Suggested MTF ILdd fitted reference line, limit lines and associated equations for Annex 179B

802.3dj D1p4 comments #139, 140, & 142

Steve Sekel, Kevin Mammenga, Ray Schmelzer
Wilder Technologies

Figure 179A-1—Host-Nominal to Host-Nominal, Cable assembly, and test fixture insertion loss at 53.125 GHz

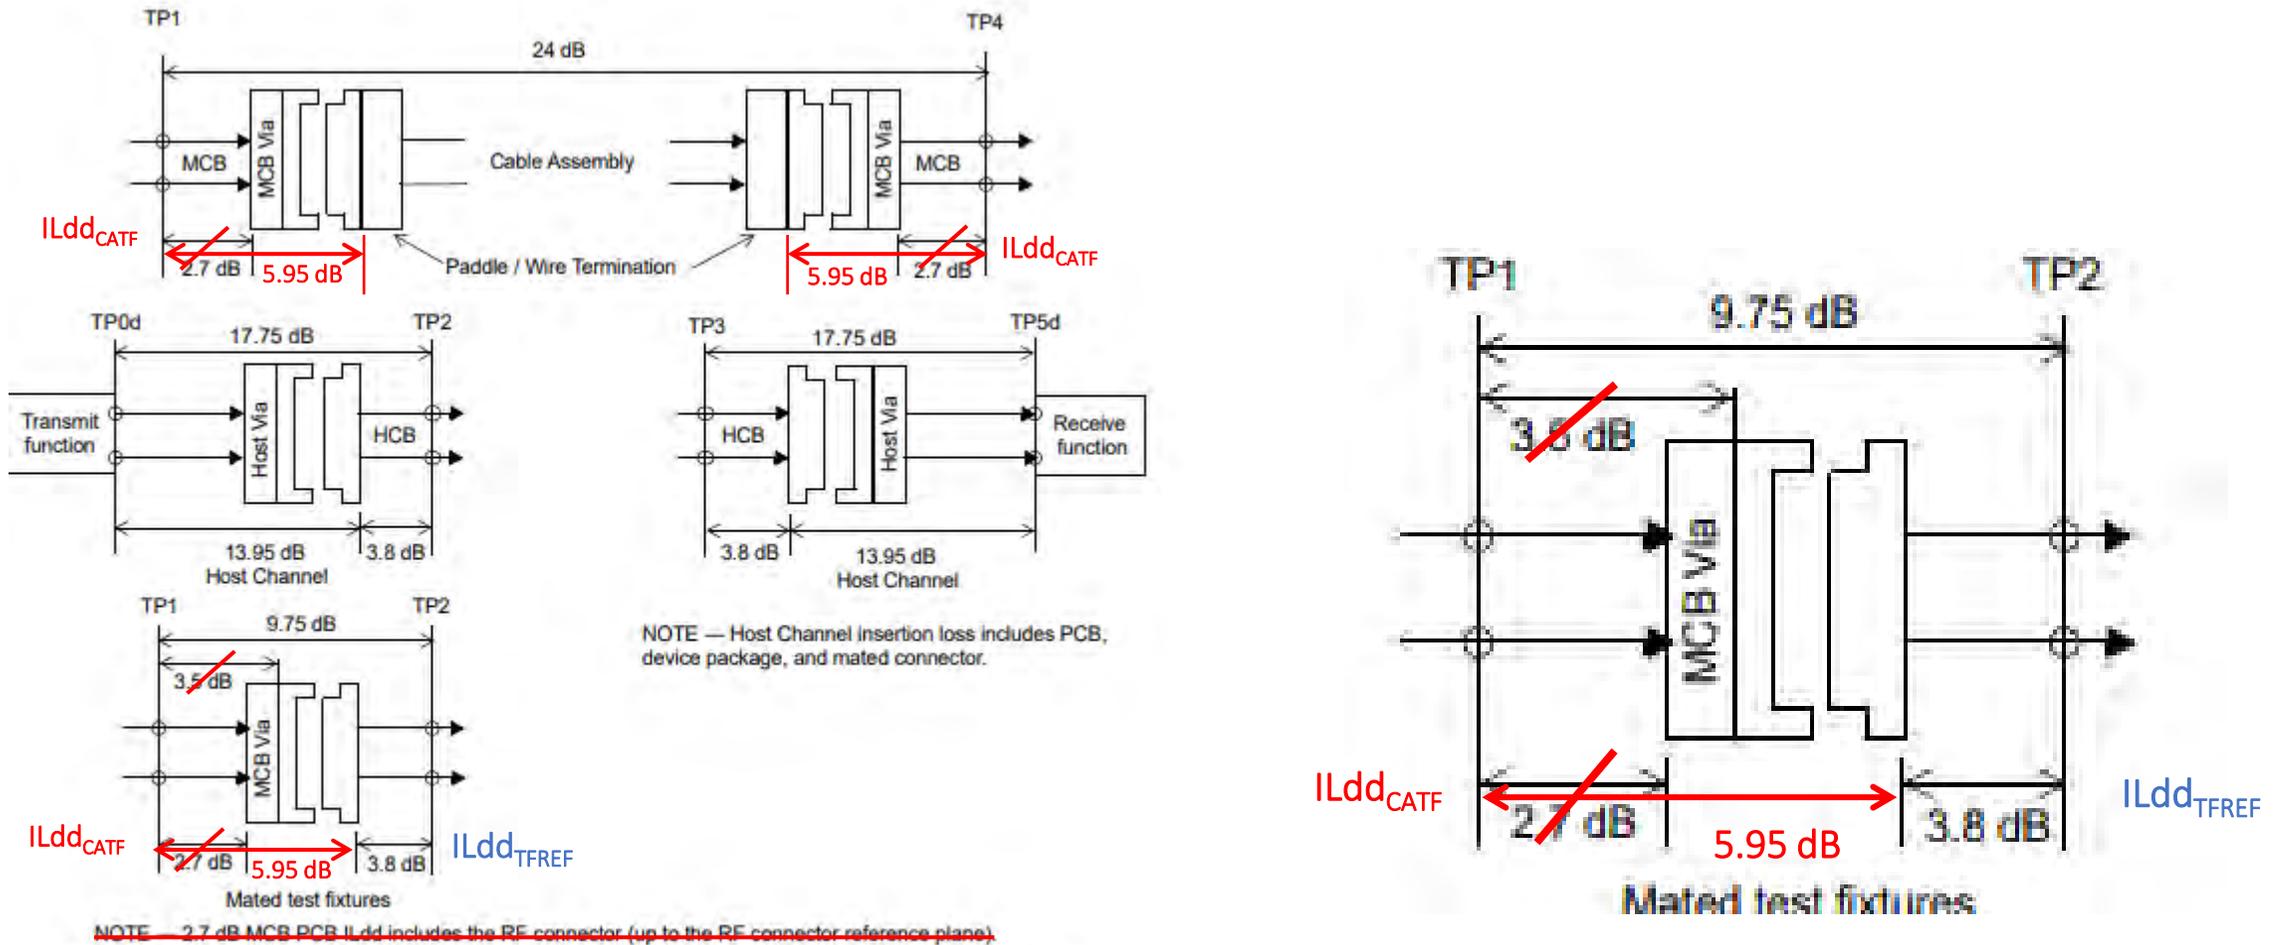
Figure 179A.1 correction (comment #140)

MTF Measurement Setup & Curve Fitting Notes

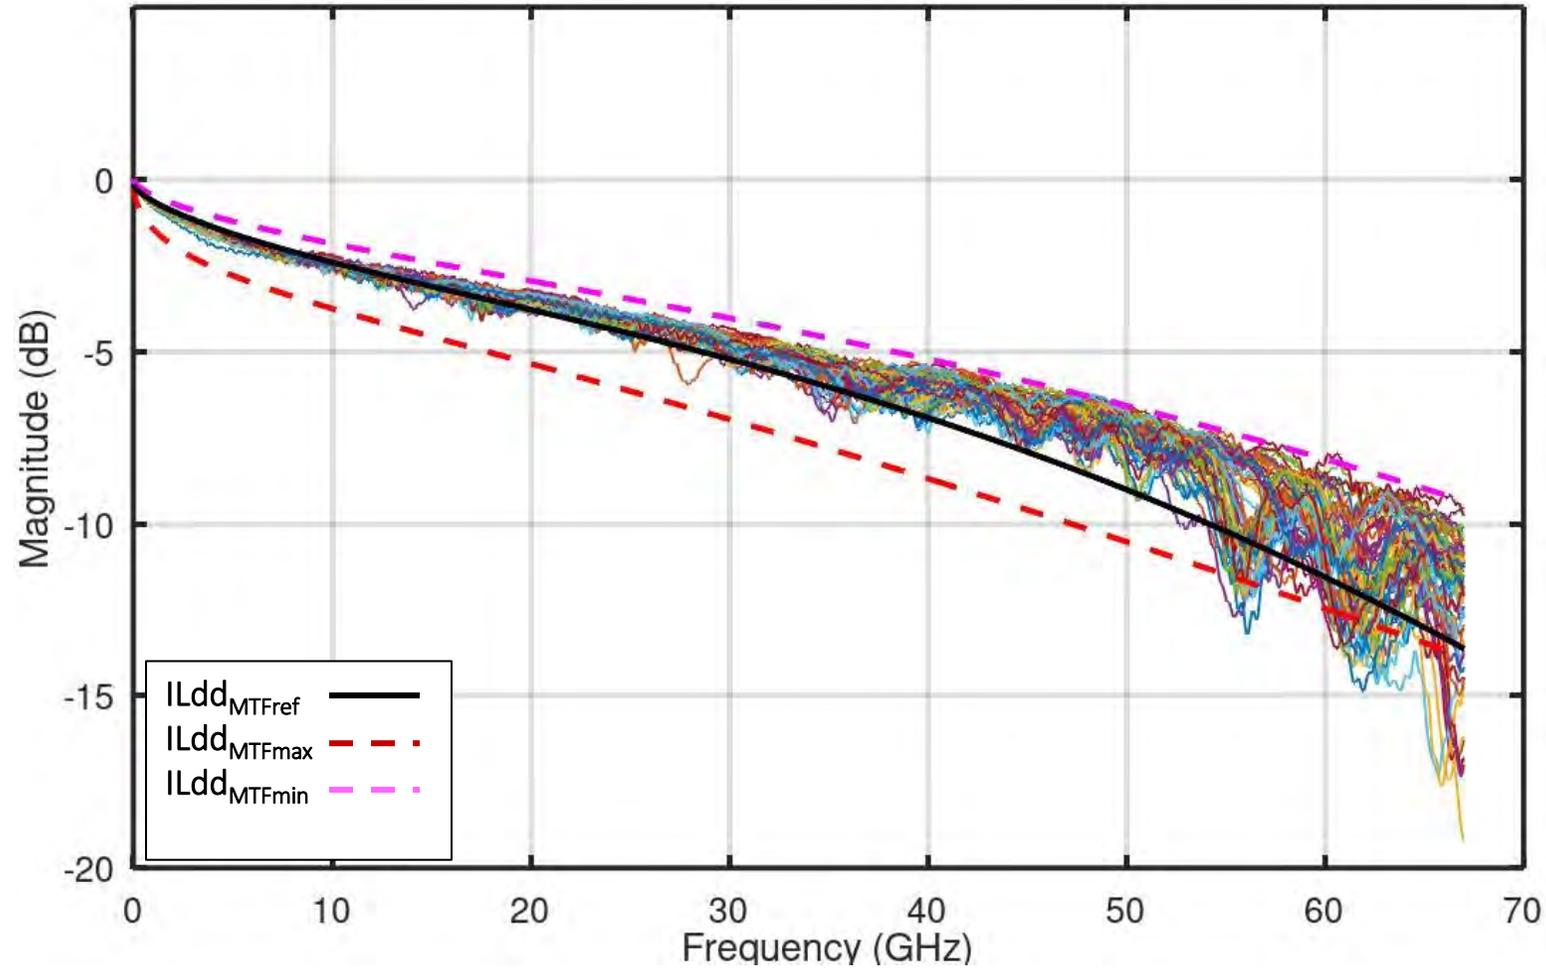
- Prototype HCB and MCB built with second generation module connector
- Based on data from 4 HCB + MCB sets
- 1.85 mm and 1.0 mm instrument connectors (2 each)
- S4P data measured to 110 GHz stop freq.; 10 MHz step size

- MCBs not tuned to target ILdd
 - Additional IL will be required
 - Current fixture sets not compliant – anticipate less spread between short and long legs to connect to PCB in future MDI connectors
